Cory Riverside Energy Park

Written Representation (WR) from Friends of Crossness Nature Reserve (FoCNR)

An indicative schematic of the impact of current, approved and proposed developments on the Crossness Marshes Nature Reserve

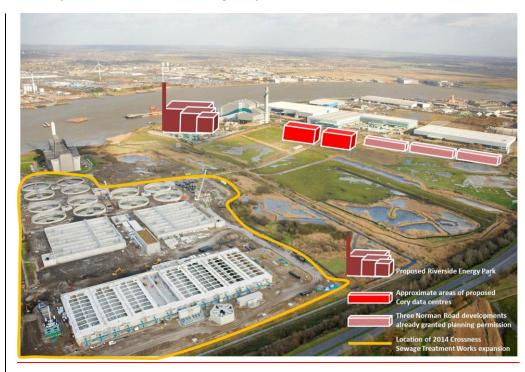
Development encroachment along the perimeter of Crossness Nature Reserve

Cumulative impacts on Wildlife

The Friends of Crossness have worked closely with Thames Water's Bio-diversity Team Manager to draw together our experiences and wildlife records to consider the cumulative impact on the nature reserve and its wildlife. As a result we make a joint representation on this section. We feel that the proposal has not adequately taken into account the cumulative biodiversity impacts of the REP with the consented the Data Storage Centres (15/02926/OUTM – approved 11/7/2016) and '3 industrial units for mixed-use" (13/00918/OUTM) which will have considerable biodiversity impacts. The consented data centres are on open-mosaic habitat that support a number of rare and scarce breeding birds.
